Subject: Oconee Nuclear Station
Docket Numbers 50-269, 270, and 287
Response to Request for Additional Information
Pertaining to the License Amendment Request (LAR)
for RPS/ESPS Digital Upgrade
Technical Specification Change (TSC) Number
2004-09, Supplement 2

**Attachment 1 – Non Proprietary
Duke Response to Request for Additional Information (RAI)
Oconee Nuclear Station License Amendment Request
for RPS/ESPS Digital Upgrade**

Figure G2—Communication between safety channels (Two-way communication)

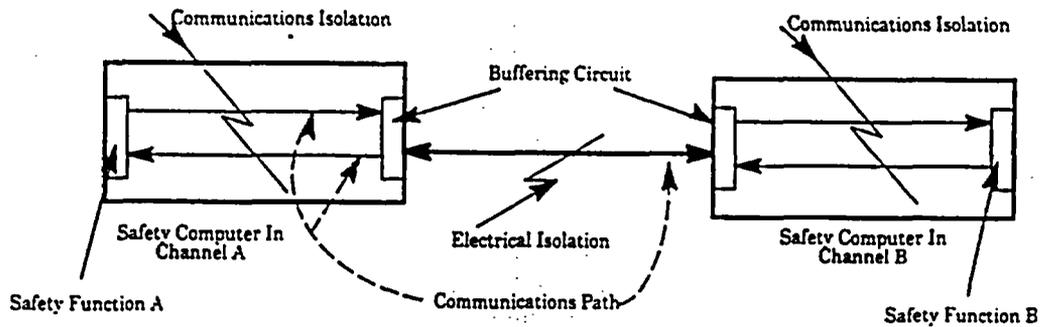
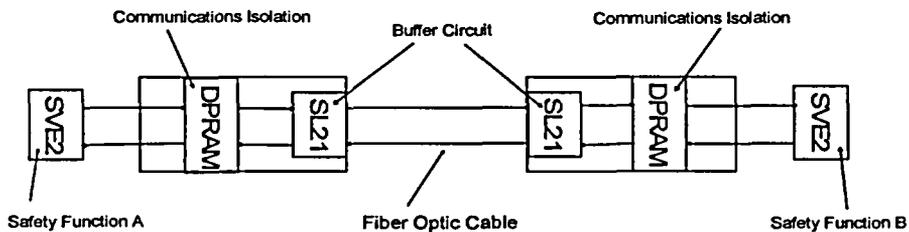
How is the requirement for channel independence maintained in accordance with IEEE 279-1971, as referenced in the Duke Power specification item 5.4.f?

Through the use of buffering circuits, an acceptable method of inter-channel communication prevents adverse interactions such as hand-shaking errors, buffer overloads and processing interrupts. IEEE 7-4.3.2 Annex G provides Figure G2 as an acceptable method for meeting the separation requirements between safety channels. That figure is duplicated below:

The RPS/ESPS uses a similar inter-channel communication method. The figure below depicts the inter-channel communication method used within the RPS/ESPS:

The following table compares the components of the RPS/ESPS to Figure G2 of IEEE 7-4.3.2:

IEEE 7-4.3.2 Annex G Figure G2	RPS/ESPS
Electrical Isolation	Fiber optic cable
Buffer Circuit Channel A	ProfiBus controller Channel A (Communications module SL21)
Buffer Circuit Channel B	ProfiBus controller Channel B (Communications module SL21)
Communication Isolation Channel A	Dual Port RAM Channel A (Communications module SL21)
Communication Isolation Channel B	Dual Port Ram Channel B (Communications module SL21)
Safety Function A	Function Processor Channel A (Controller module SVE2)
Safety Function B	Function Processor Channel B (Controller module SVE2)

The RPS/ESPS communication path between two safety processors use SL21 communication interface modules and fiber optic cables to interface between separate safety channel processors. Through the use of dual port RAM (DPRAM), the SL21 interface, the processors can communicate autonomously, so that the safety function processing is not compromised. In addition, the SL21 removes the communication burden from the safety processors.
